RESOLUTION OF THE TOWN OF ST. LEO TOWN COMMISSION
APPROVING SAINT LEO UNIVERSITY INC. SOCCER/LACROSSE FIELDS AND
PARKING GARAGE SITE PLAN/VARIANCE REVIEW-SPR/VAR #11-F-
MODIFICATION #2 WITH CONDITIONS.

SITE PLAN (SPR)/VARIANCE (VAR) REVIEW STAFF REPORT
SPR/VAR#11-F-MODIFICATION #2
Saint Leo University Soccer/Lacrosse Fields and Parking Garage
Town Commission Meeting February 13, 2012

Request: Approve a second modification to a previously approved site plan for the Soccer/Lacrosse Fields and Parking Garage project with wetland/forested area and wetland/forested area buffer variances

ATTACHMENT 6
NE SPREADER SWALE

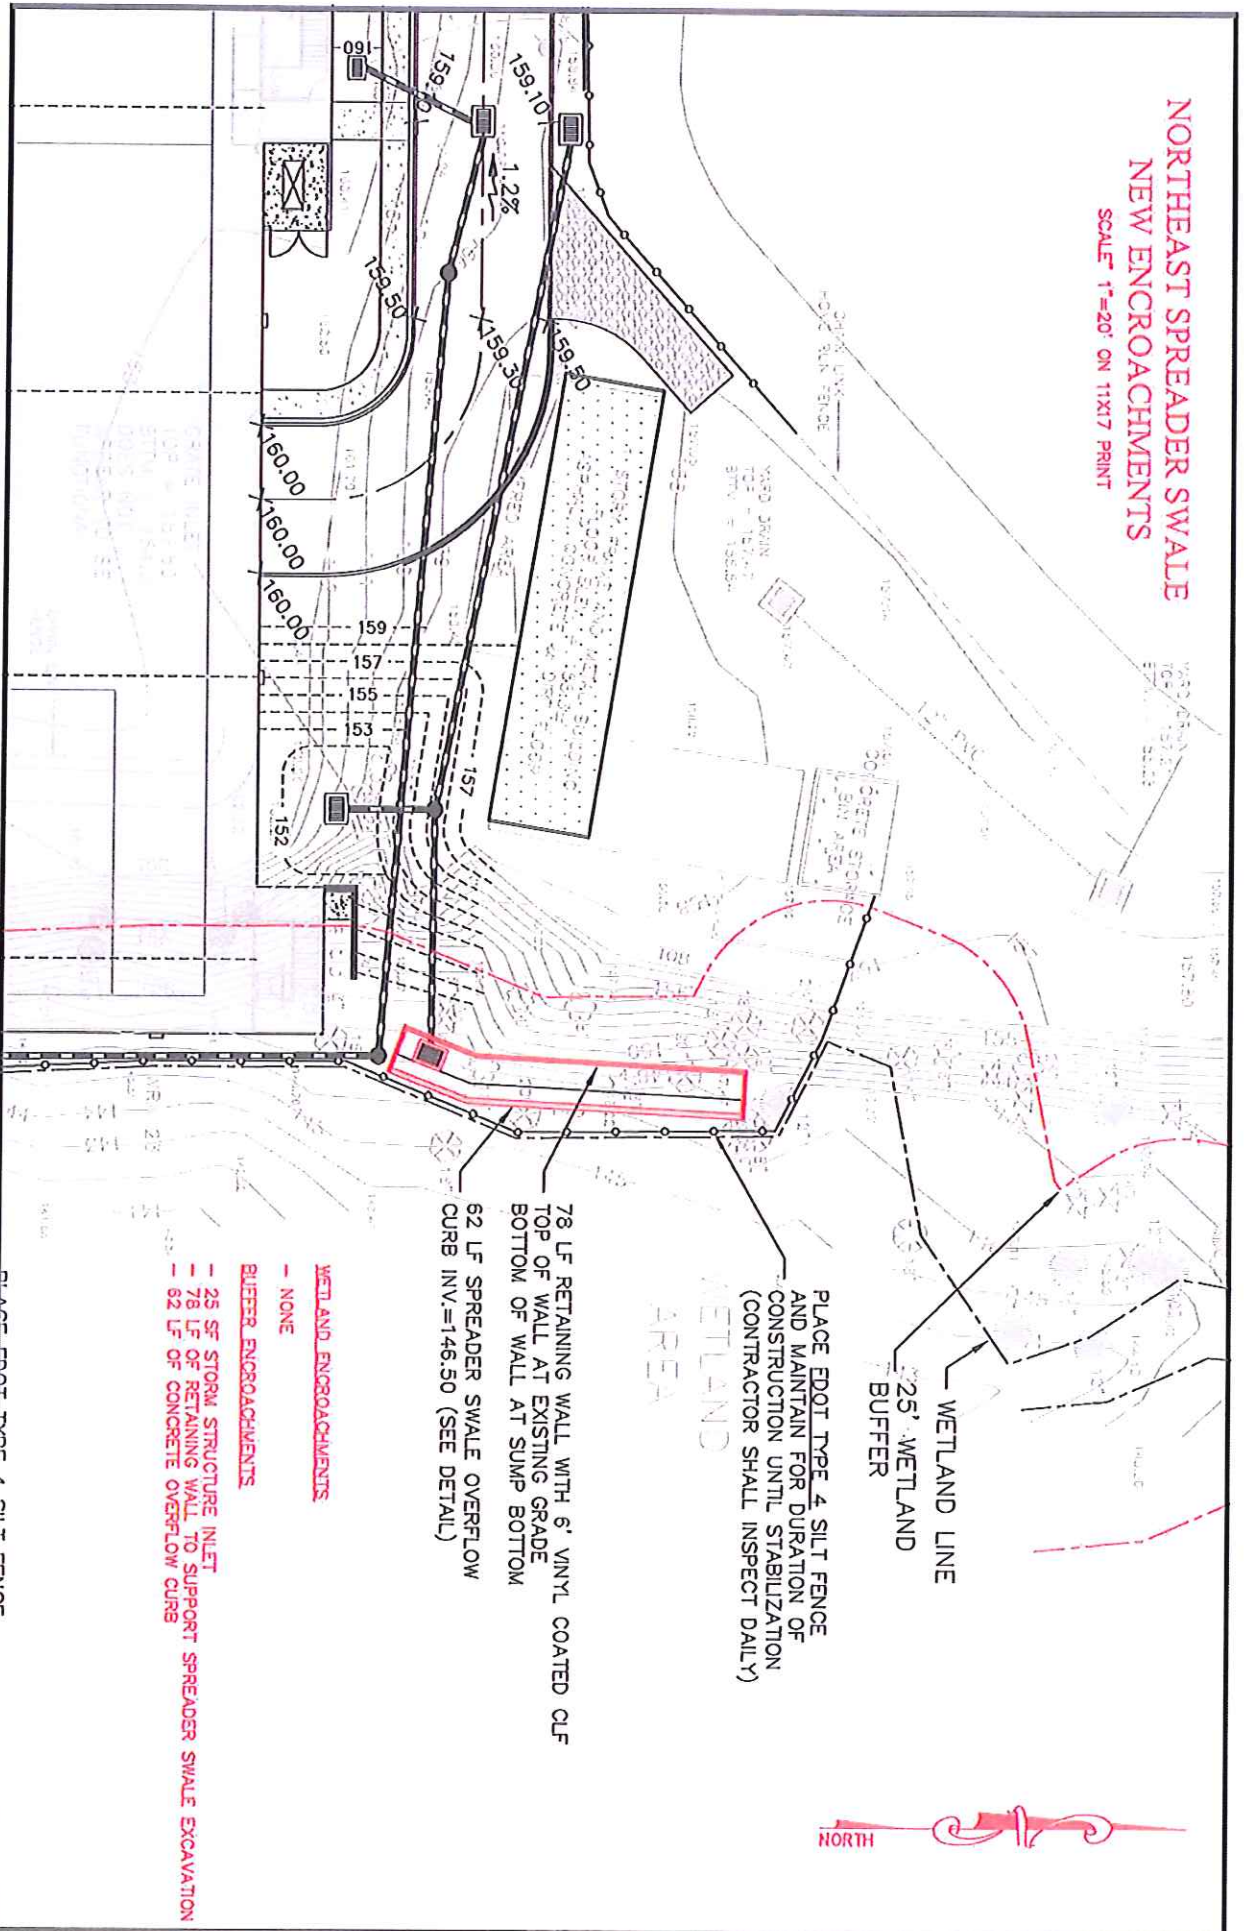
The northeast corner of the project area also requires a modification that will require the Town's consideration. The original site plan reviewed by the Town depicted a stormwater pipe discharging runoff from the northern part of the complex to the eastern wetland. The original plan proposed a "bubbler" at the end of the stormwater pipe to dissipate the energy of the stormwater flow as it exited the pipe to protect the bank from further erosion. This stormwater discharge is located at a specific point on the bank to ensure that the wetland will continue to receive adequate hydration from stormwater flows. When this design was proposed to SWFWMD within the Environmental Resource Permit (ERP) Application, the District rejected the proposed "bubbler" because of the potential for continued bank erosion. However, in lieu of the "bubbler" they suggested and subsequently permitted a spreader swale. This swale was, in their opinion, a more effective alternative to slow down the stormwater flow and better protect the bank from erosion ([Attachment 6 – Spreader Swale](#)). This change requires a bigger "footprint" for the swale and will require the removal of additional trees. The spreader swale was located in a position to minimize the number of trees to be removed but also function effectively as part of the stormwater management system.

ATTACHMENT 7
TREE LOCATION PLAN

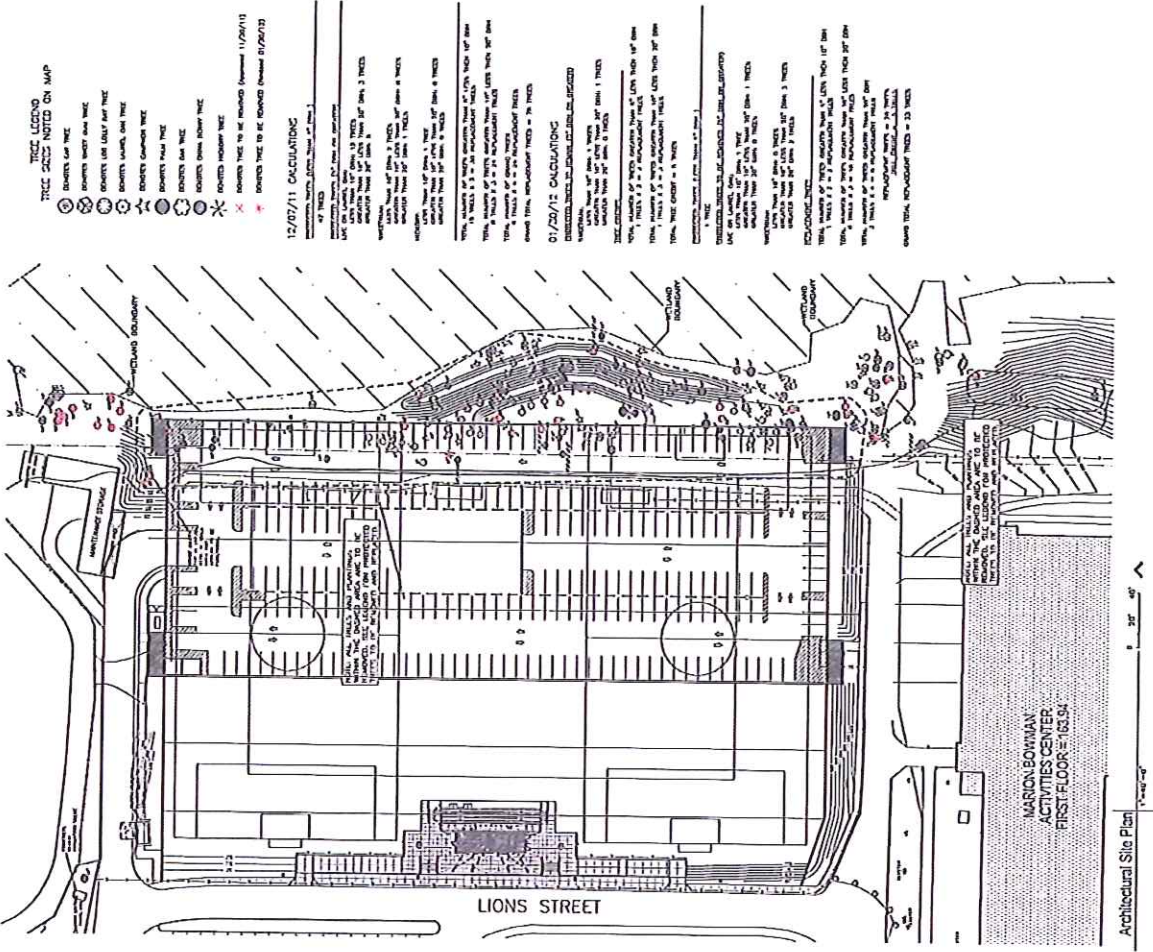
Table 1 outlines trees that must be removed for the proposed alterations to the NE and SE banks as required by SWFWMD. The location of these trees is depicted on Attachment 7.
